**Board of Directors Electronic Mail Meeting Agenda  
Thursday, March 5, 2026, 9:00 a.m.**

### Major Thoroughfare Plan Variance Request

#### Ozarks Transportation Organization (Springfield, MO Area MPO)

OSZARK SPECIAL ROAD DISTRICT  
 CHRISTIAN COUNTY, MISSOURI  
**ENTRANCE PLAN**  
 FREMONT ROAD  
**SIGHT DISTANCE AND ENTRANCE SPACING**

Roadway – Fremont, south of Route CC between Calabash and Fremont Hills Drive

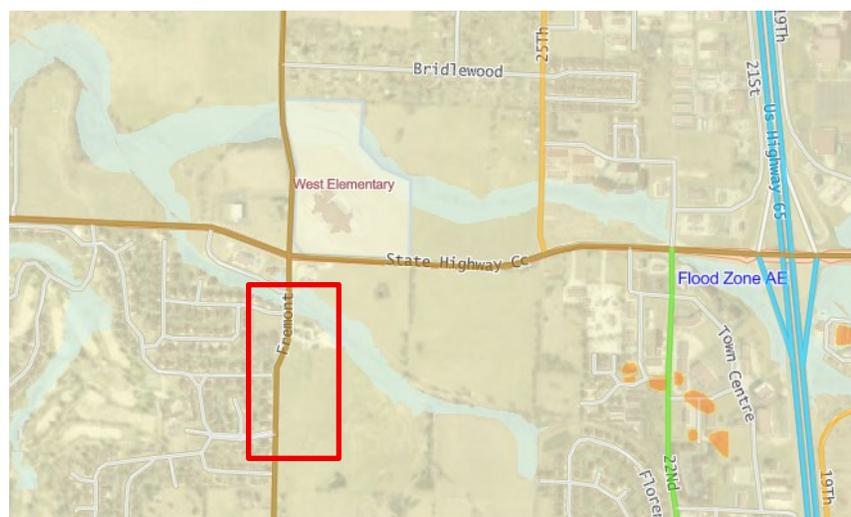
Request – To accommodate a safe sight distance, the property owner is requesting a driveway that would be placed 265 feet from the Fremont Hills entrance to the south, with spacing to the north beyond what is required (330 feet).

As stated in the included application – “Due to roadway constraints with sags and crests as well as a large S curve it is not possible to meet both the sight distance and driveway spacing requirements. Therefore, it has been determined that the driveway should meet sight distance requirements and request a variance for the driveway spacing.”

The Technical Planning Committee voted to recommend that the jurisdiction be granted authority to vary from the OTO spacing standard in this instance, with the understanding that the decision is subject to final approval by the governing agency and that accepted engineering practice and appropriate site plan review apply.
